Clinton Power Station

RS-01-279

Subject: Additional Information Supporting the License Amendment Request to Permit
Upated Power Operation at Clinton Power Station

Additional Information Supporting the License Amendment Request to Permit Upgraded Power Operation at Clinton Power Station

Figure 4.2-1 Simplified VC Diagram - A Train "Hi Rad"

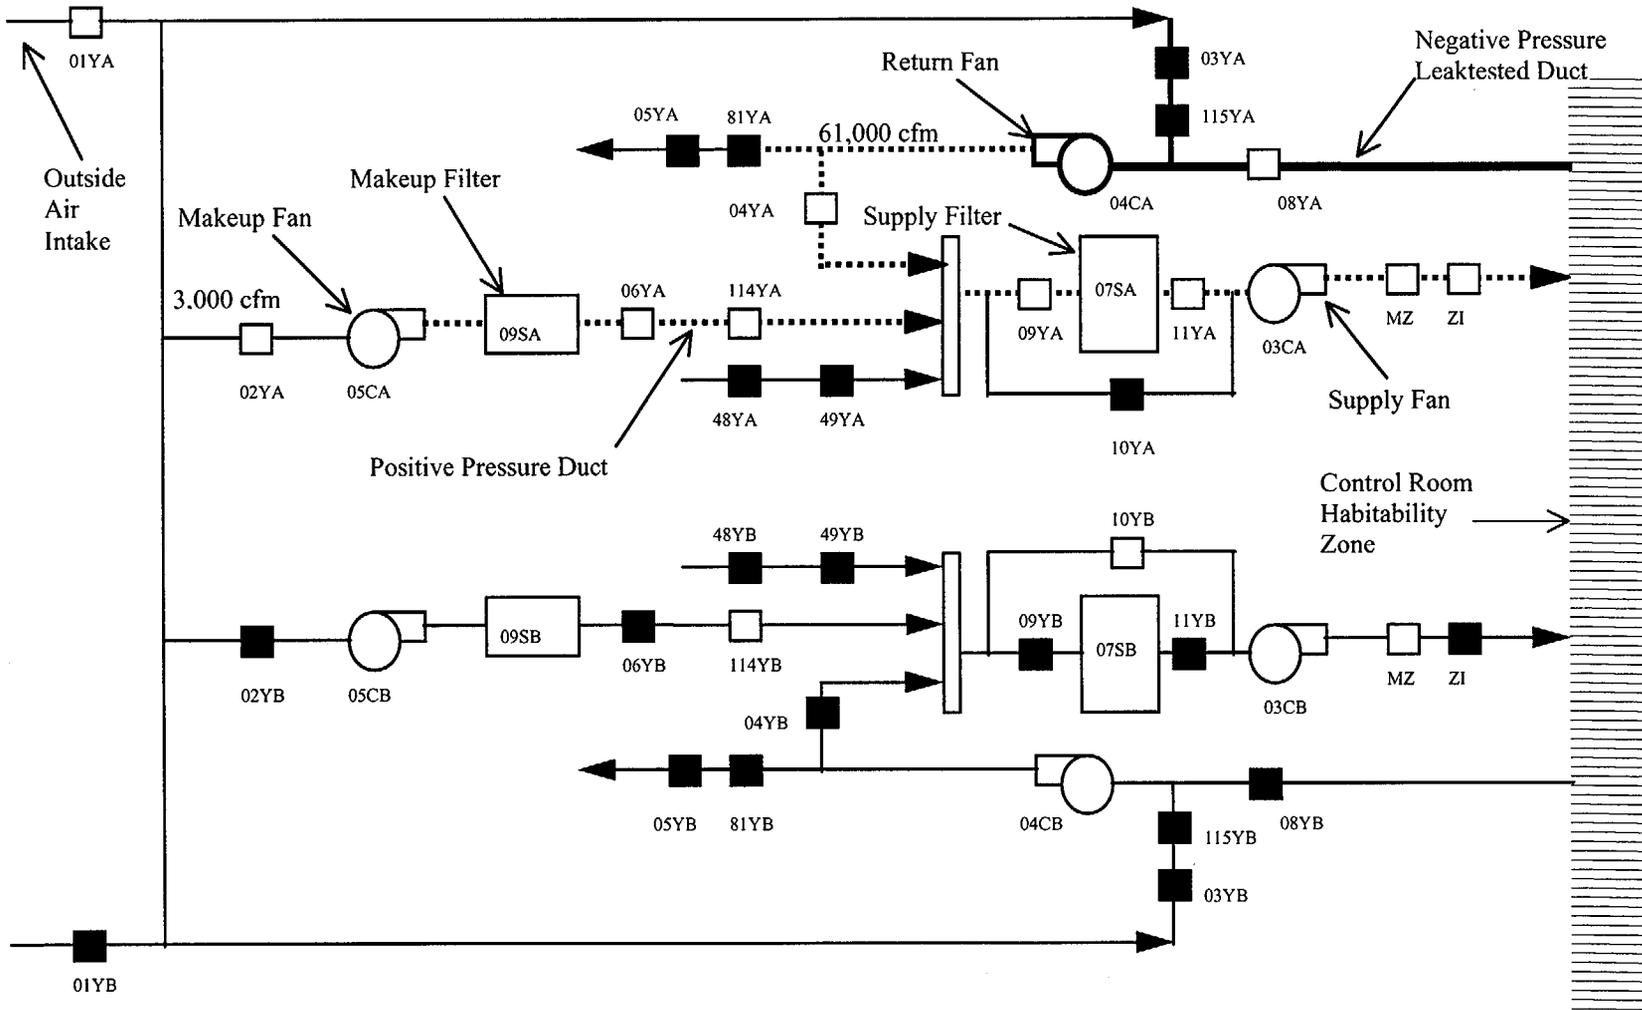
The staff has reviewed Amergen's response dated October 17, 2001 to its request for additional information. Question 4.2e requested: "Please provide a justification for control room unfiltered inleakage assumptions that have not been substantiated by appropriate integrated boundary leakage testing." Based on the information provided, the staff finds the Amergen response to be insufficient. Amergen is requested to supplement its response to RAI Question 4.2e with the requested justification of the CRS unfiltered inleakage assumption.

Several power reactors (representing over 20% of the U.S. plants, including those with filtered zone isolation and pressurization) have performed integrated testing of their control room inleakage, and in all but one case, the test results showed inleakage in excess of the facility's design basis. Based on this experience, concluding that the positive pressurization surveillance tests would result in no unfiltered inleakage (other than access doorways) during an accident condition is questionable. Given Amergen's projected post-EPU dose for the control room of 29 rem out of an allowable 30 rem, a increase in unfiltered inleakage could result in doses exceeding GDC-19.

The sources of contaminated air used in the dose assessment are based on the design of the CRVS, which utilizes zone isolation with filtered recirculation and zone pressurization. A simplified diagram of the system is shown in Figure 4.2-1. The system consists of two independent trains composed of a supply fan, a return fan, a makeup fan, a supply air filter package and a makeup air filter package. Each train is capable of

A significant portion of the ductwork and equipment in the CRVS is located outside the control room habitability zone. Ductwork outside the control room is a potential pathway for inleakage of unfiltered and potentially contaminated outside air if the ductwork is at negative pressure relative to the outside atmosphere. The only portion of the system that is at negative pressure during the "Hi Rad" mode of operation is the ductwork upstream of the return fan. Technical Specifications (TS) assure that the actual inleakage into this ductwork is less than the value used in the dose assessment. Any leakage into this ductwork passes through the supply filter, so this is considered filtered inleakage. The design of the system is such that the remainder of the ductwork downstream of the charcoal filters is maintained at positive pressure, which precludes the infiltration of additional outside air into the CRVS.

This design was selected to preclude unidentified, unfiltered leakage of outside air into the control room envelope. The supply of 3,000 cfm of outside air is sufficient to maintain the pressure inside the control room at greater than 1/8-inch water gauge relative to all adjacent areas. Also, control room access is controlled through vestibules with two doors in series to preclude leakage into the control room during access or egress. The dose assessment conservatively assumes 10 cfm of unfiltered inleakage, which is in addition to the 650 cfm of filtered inleakage into the ductwork outside containment. The conclusion that the inleakage assumed in the Clinton Power Station (CPS) dose assessment is conservative is based on three considerations.
